ISSUE: Permit to Demolish/Capsulate (partial) and Certificate of Appropriateness for an addition and alterations

LOCATION: Parker-Gray District
1215 and 1215 ½ Queen Street

STAFF RECOMMENDATION

1 EXISTING SOUTH ELEVATION
A-1 SCALE: 1/8" = 1'-0"

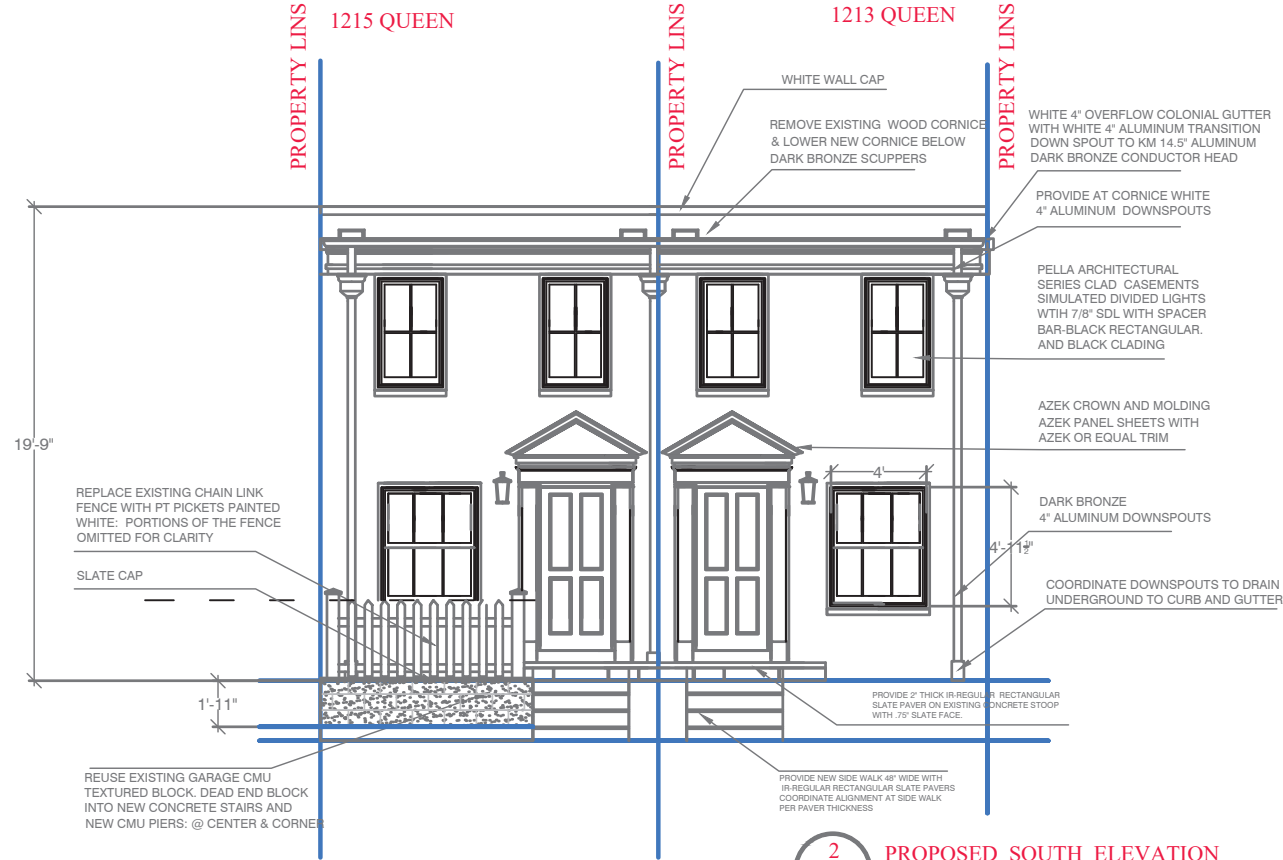
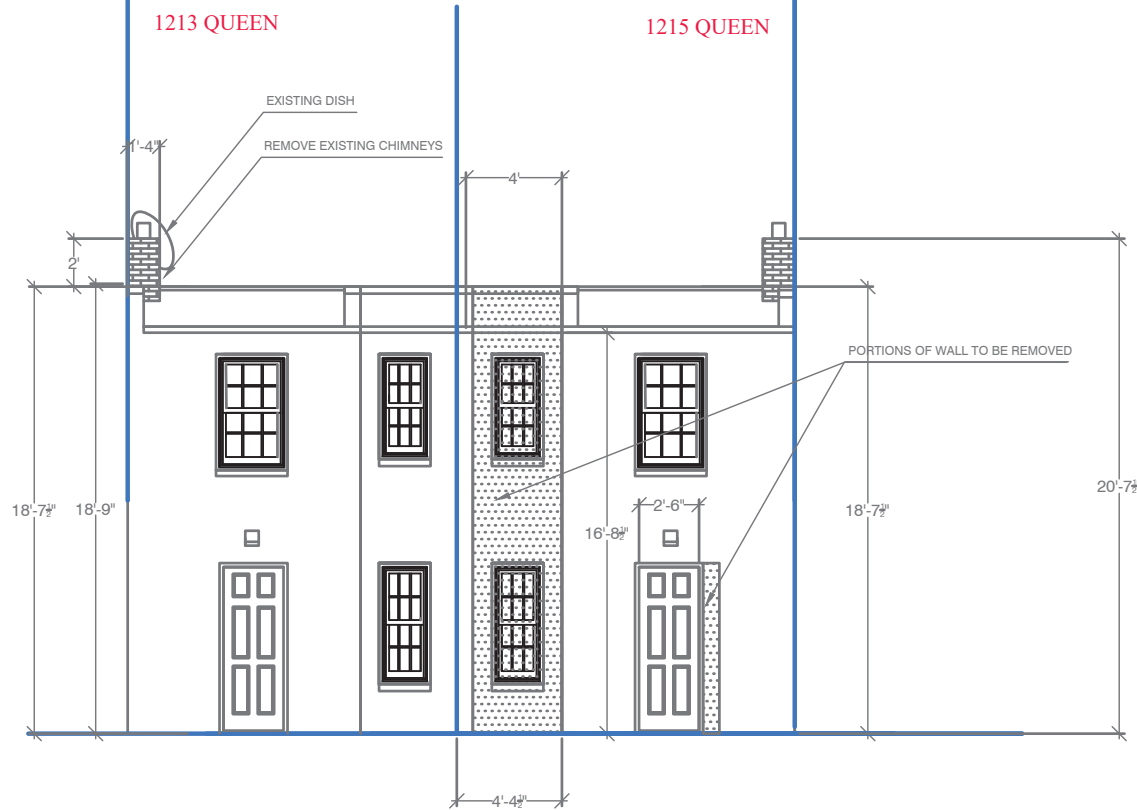
Additionally, the applicant is proposing the demolish the existing chimney. The *Design Guidelines* state that “chimneys are important functional elements of a building and provide visual variety to the roofline.” Staff recommends that the existing chimney be retained and repaired as needed because it has an important impact on the roofline and, overall visual composition of the building.

The applicant also proposes to replace the existing six-panel doors and to add a triangular door pediment over the existing door surround on the south elevation. Staff objects to the door hood on the façade because these architectural features are not compatible with the existing features on the property. The door on the south elevation will be a four-panel wood door. Staff has no objection to the proposed door on the north elevation, as it will be minimally visible from the public alley and does not require Board review as stated in the Parker-Gary Residential Reference Guide. The door opening on the north will be moved 11” towards the west wall but will remain the same size as the existing.

1. The proposed triangular pediment be removed, or the applicant work with staff to find an architecturally appropriate rectangular pediment;
2. The existing chimney be retained and repaired as needed; and,
3. The applicant should thoroughly document the garage prior to demolition.

3 EXISTING NORTH ELEVATION
A-1 SCALE: 1/8" = 1'-0"

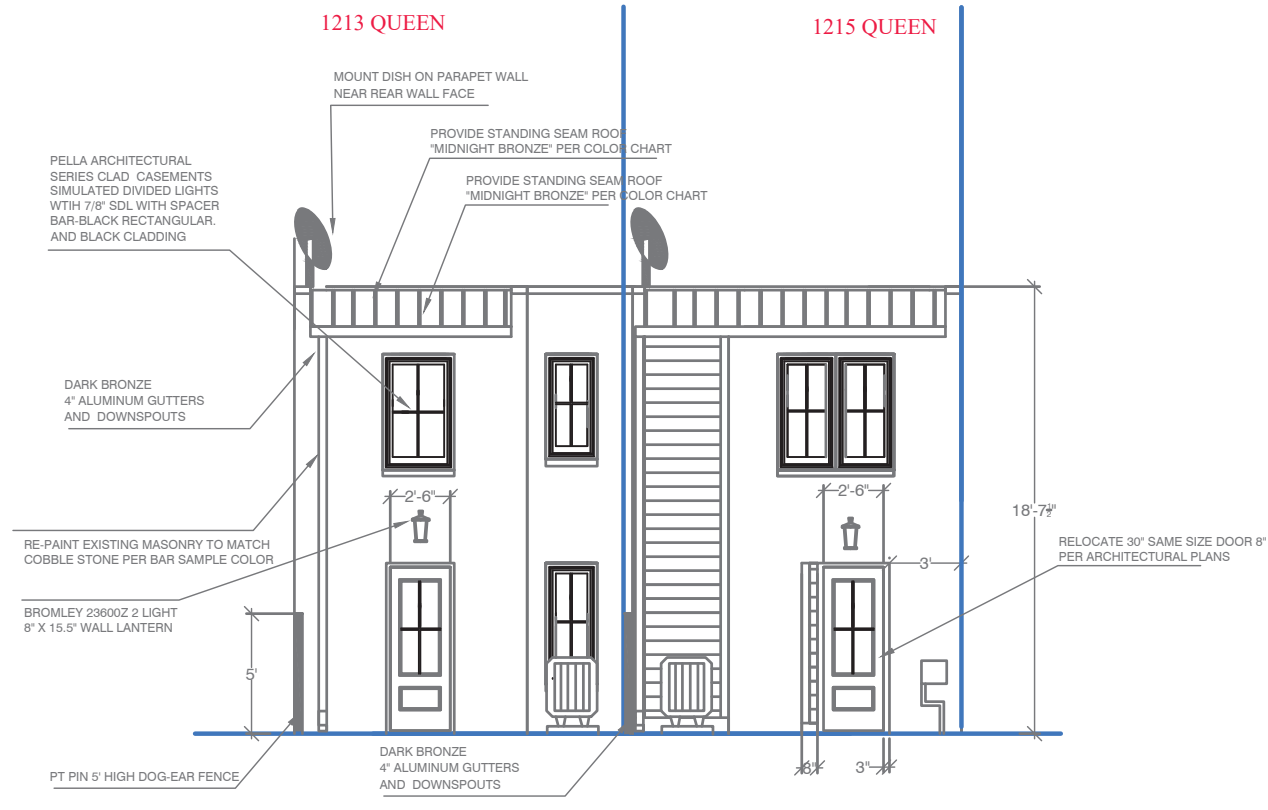
the applicant is proposing to enlarge the existing window from a single window to a double. Staff has no objection to the new window.
